UNITED STATES PATENT AND TRADEMARK OFFICE

APPLICATION NO.	FILING DATE	FIRST NAMED INVENTOR	ATTORNEY DOCKET NO.	CONFIRMATION NO.
10/669,971	09/24/2003	Nathan A. Winslow	5490-000337	4885

Office Action Summary	Application No. 10/669,971	Applicant(s) WINSLOW, NATHAN A.	
	Examiner Javier G. Blanco	Art Unit 3738

DETAILED ACTION

Main (fourth) drawing of the BIOMET brochure shown below:

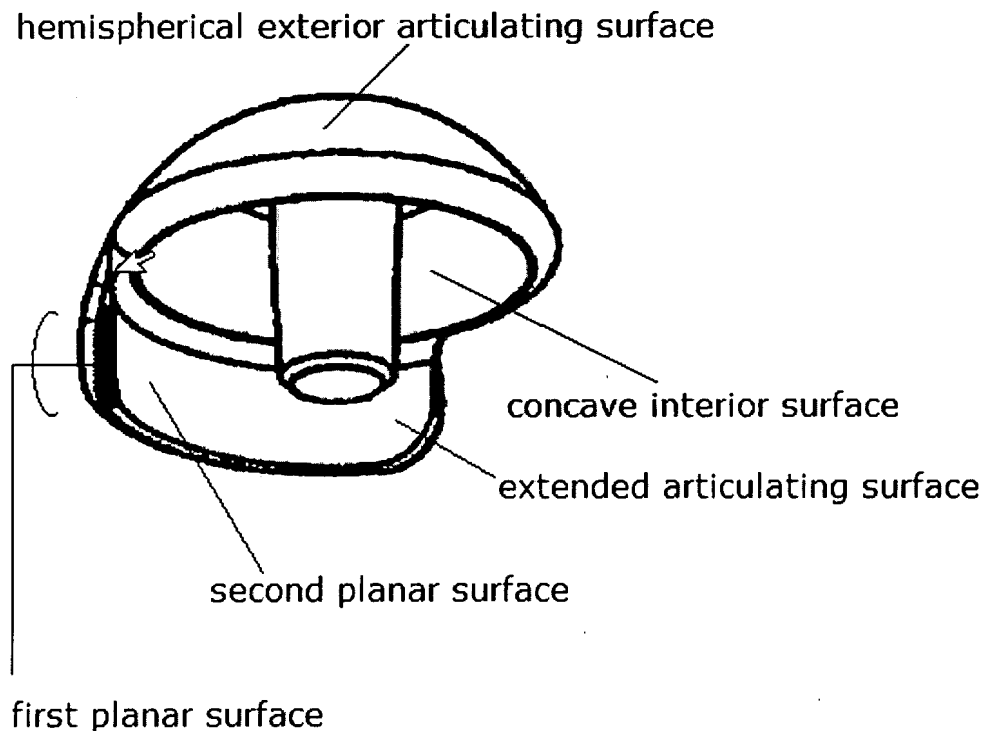
(iv) An extended articulating surface protruding from only a portion of said hemispherical exterior articulating surface, said extended articulating surface having a pair of intersecting planar surfaces, said planar surfaces being generally parallel to the integral straight anchoring device. The term “planar” is generally defined as: “Of, relating to, or situated in a plane”; “of, relating to, or lying in a plane”. The “extended articulating surface” of the BIOMET implant (see main (fourth) drawing of the BIOMET brochure below) comprises a pair of intersecting planar surfaces, said planar surfaces being generally parallel to the integral straight anchoring device, which pair of intersecting planar surfaces are each “situated in a plane” or “lying in a plane”. The second (i.e., lateral view) and fourth (i.e., main or fourth) drawings show the extended articulating surface as comprising a “step”.

The Examiner respectfully disagrees. The term "planar" is generally defined as: "Of, relating to, or situated in a plane"; "of, relating to, or lying in a plane". The "extended articulating surface" of the BIOMET implant (see main (fourth) drawing of the BIOMET brochure above) comprises

a pair of intersecting planar surfaces, each of said planar surfaces are “situated in a plane” or “lying in a plane”, and being generally parallel to the integral straight anchoring device.

A representation of Figure 22 of Long et al. (US PG Pub No 2004/0193277 A1) is shown below:

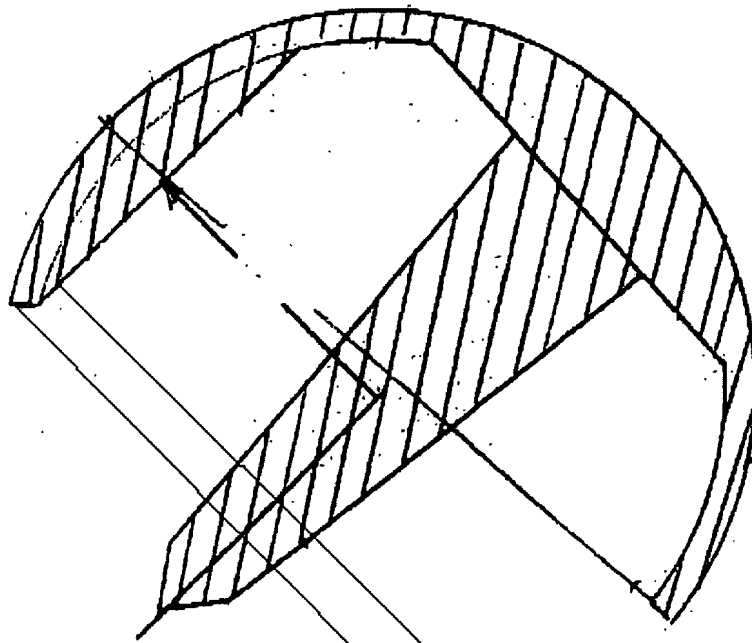
- (iv) An extended articulating surface (second body articulating surface 32 of second body 30) protruding from only a portion of said hemispherical exterior articulating surface, said extended articulating surface having at least one planar second interior surface, including a planar “V” shaped inner surface (see Figures 21 and 22). Long et al. also disclose the method as claimed in claims 19-22 and 24 (see pages 4-6), including resecting the humeral head to form planar surfaces. The term “planar” is generally defined as: “Of, relating to, or situated in a plane”; “of, relating to, or lying in a plane”. The “extended articulating surface” of the Long et al. implant comprises a second interior surface “situated in a plane” or “lying in a plane”.

Two planar inner surfaces (forming a V-shape)

Long et al. disclose the invention as claimed except for particularly disclosing recently added limitation “a pair of intersecting planar surfaces, said planar surfaces being generally parallel to an integral straight anchoring device and forming a “V” shaped surface”. However, this is already known in the art. For example, Sutter et al. disclose a monolithic resurfacing humeral implant comprising an extended articulating surface having a pair of intersecting inner planar surfaces (Figures 1-3, 7, 9, and 10: ribs 3g and grooves 3f; see column 4, lines 47-64; column 5, lines 32-53), said planar surfaces being generally parallel to an integral straight anchoring device (clearly seen in Figures 1-3; see column 4, lines 47-64; column 5, lines 32-53) and forming a “V” shaped surface (see Figures 2 and 7) in order to permit the monolithic resurfacing humeral implant to be firmly and durably secured without cement (among other advantages; see Abstract; see column 4, lines 47-64; column 5, lines 32-53). Therefore, it would
